**From:** Andrew Thomas  
**Sent:** Thursday, April 7, 2022 2:17 PM  
**To:** Erin Garcia <egarcia@alamedaca.gov>  
**Subject:** FW: [EXTERNAL] Re: Draft Housing Element and related draft zoning amendments to be considered at HAB April 7 meeting - -AAPS comments

**Subject: Draft Housing Element and related 4-4-22 zoning text amendments (Item 7-C on 4-19-22 City Council agenda)**

**Re: Alameda Housing Element Update and Related Density Bonus Issues**

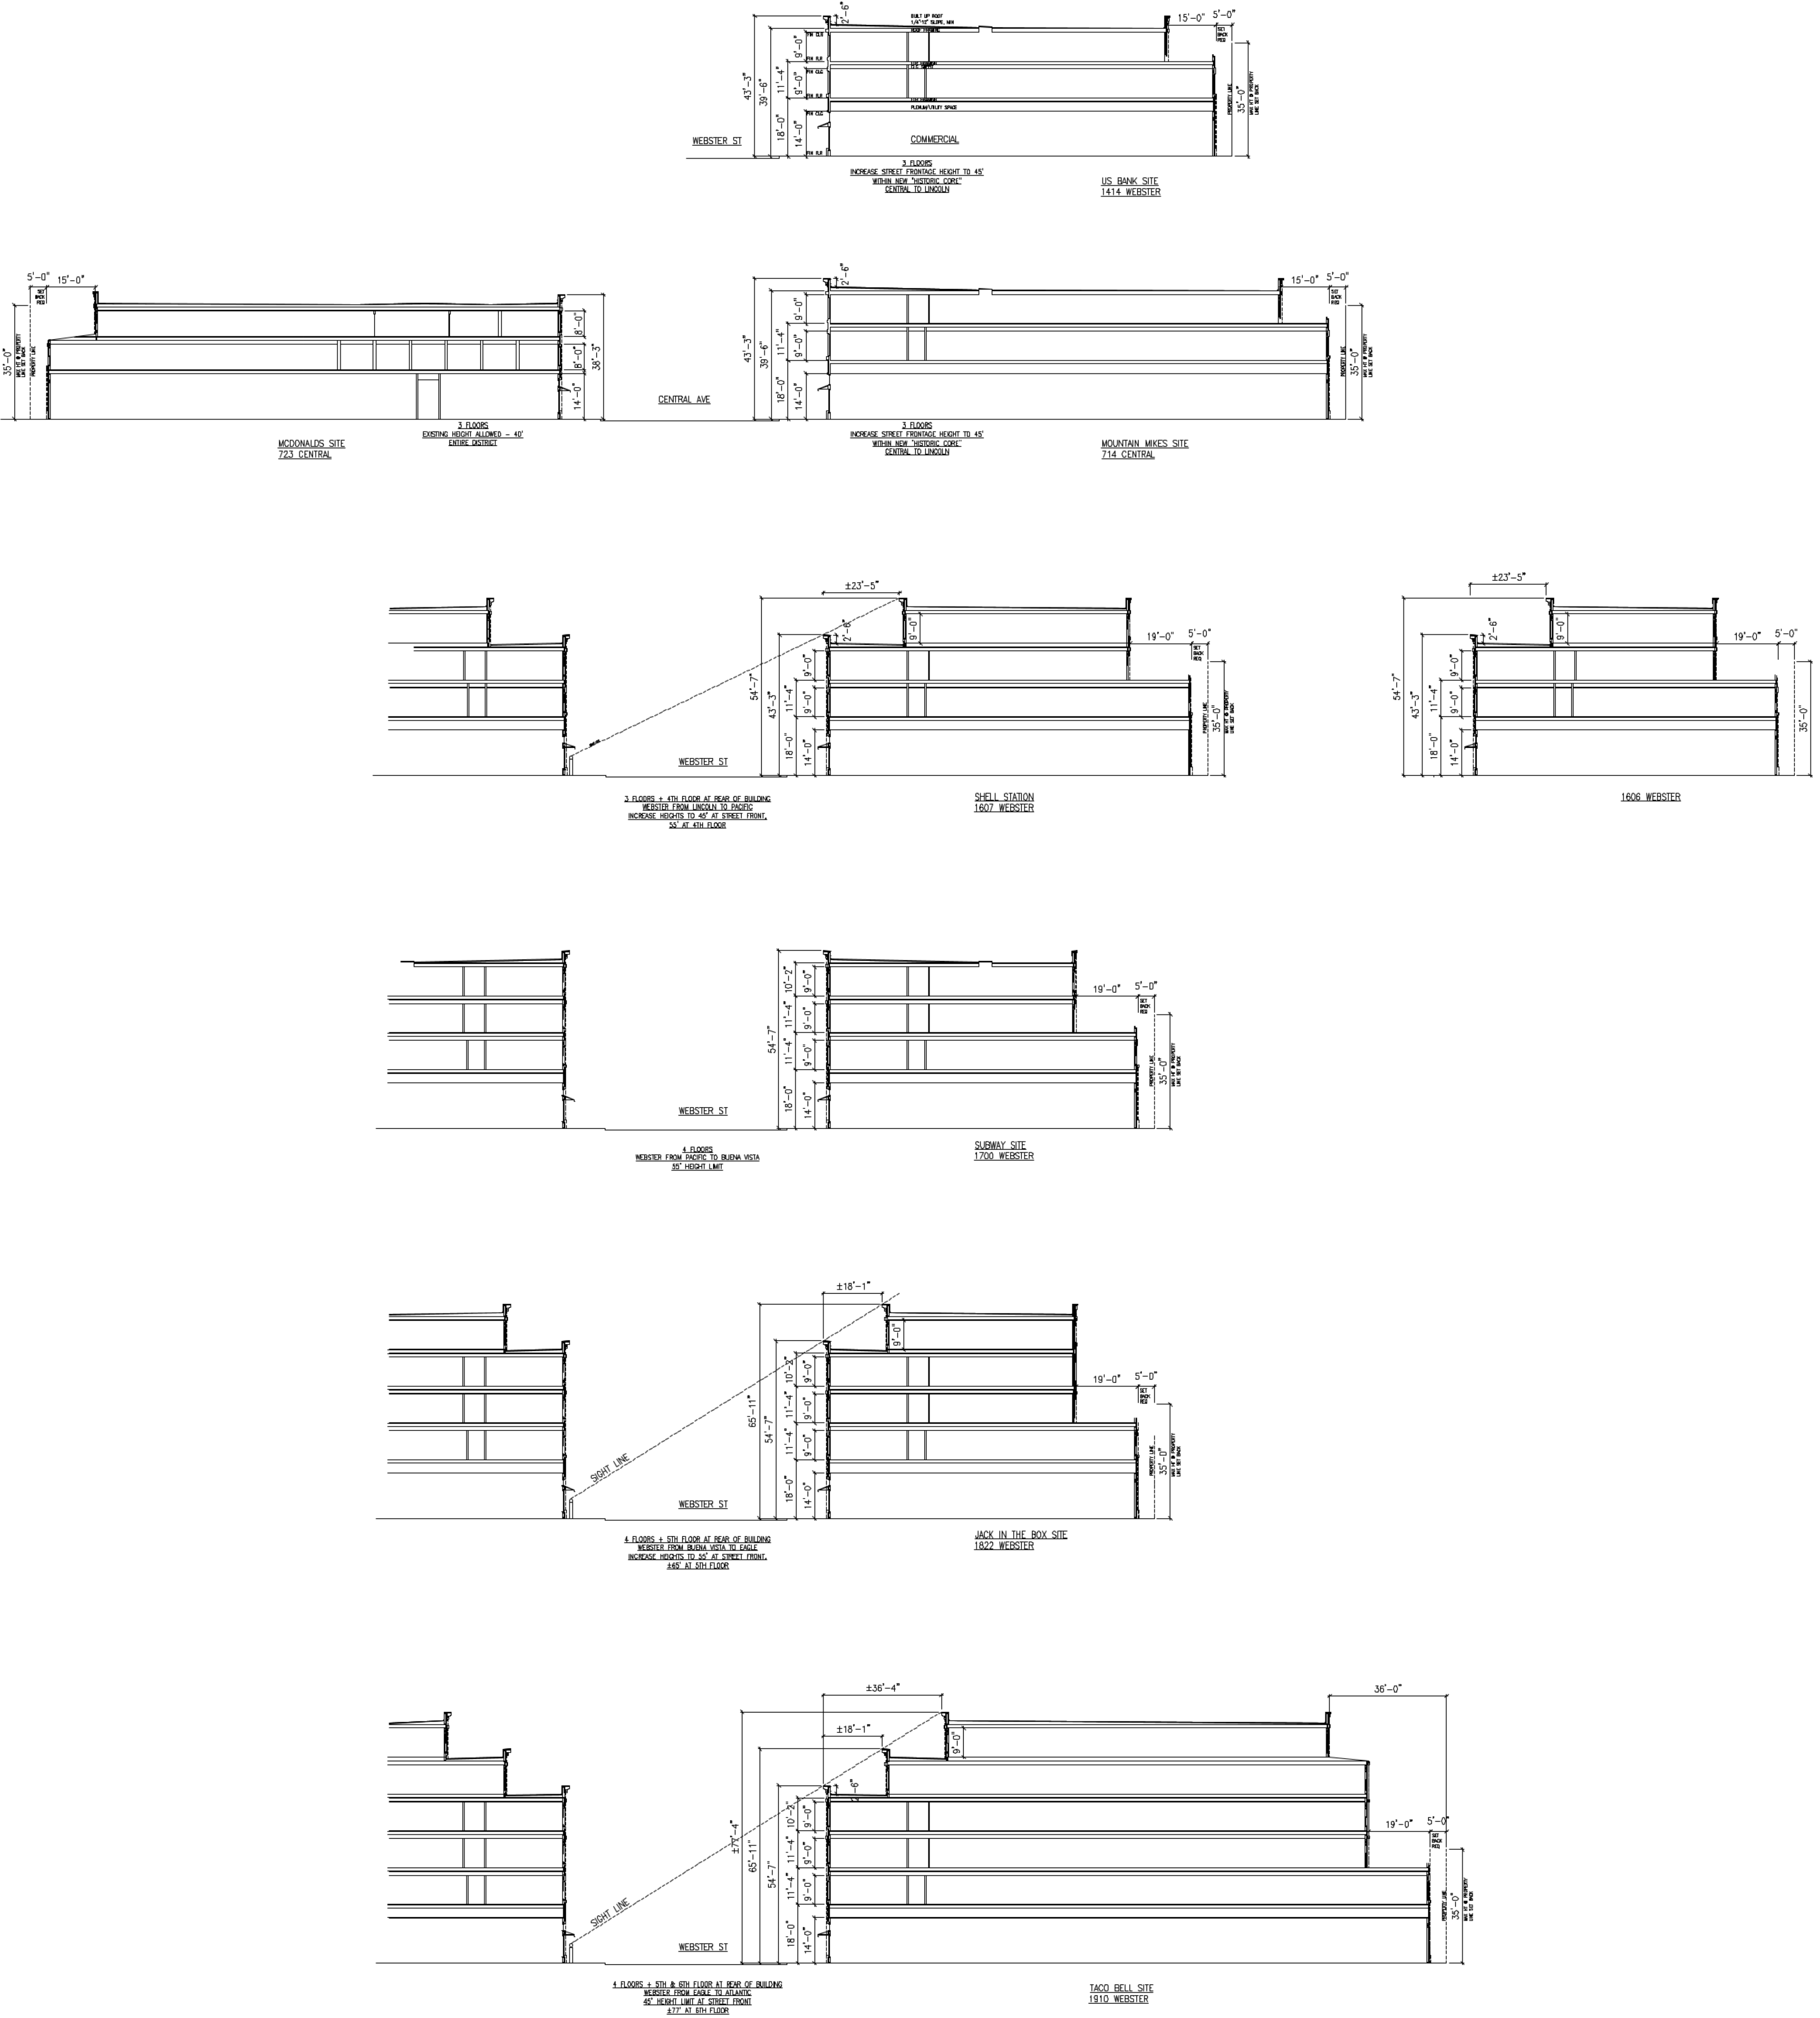
- Properties fronting onto the south side of Central Avenue - fifty five (55') feet, provided that any portion of the building that exceeds forty five (45') feet is set back at least ten (10') feet from the face of the building.
- Properties fronting onto Webster Street between Central Avenue and Lincoln Avenue, and properties fronting onto the north side of Central and south side of Lincoln - forty five (45') feet;
- Properties fronting onto Webster Street between Lincoln Avenue and Pacific Avenue and properties fronting onto the north side of Lincoln and the south side of Pacific - fifty five (55') feet, provided that any portion of the building that exceeds forty five (45') feet is set back at least ~~ten (10')~~ feet from the face of the building;

- Properties fronting onto Webster Street between Pacific Avenue and Buena Vista Avenue and properties fronting onto the north side of Pacific and the south side of Buena Vista Avenue - fifty five (55') feet; (SAME 24' SET BACK? & REAR?)

- Properties fronting onto Webster Street between Buena Vista Avenue and Eagle Avenue and properties fronting onto the north side of Buena Vista or the south side of Eagle- sixty five (65') feet, provided any portion of the building that exceeds fifty five (55') feet is set back at least ~~ten (10')~~ <sup>18'</sup> feet; and, (+ 24' SET BACK & REAR FT?)

- Properties fronting onto Webster Street between Eagle Ave and Atlantic Avenue and properties fronting onto the north side of Eagle or south side of Atlantic- ~~eighty five (85') feet.~~ <sup>80' (85') feet. w/ 18' SET BACK @ 5th FLR + 36' SET BACK @ 6th FLR + 24' @ REAR</sup>
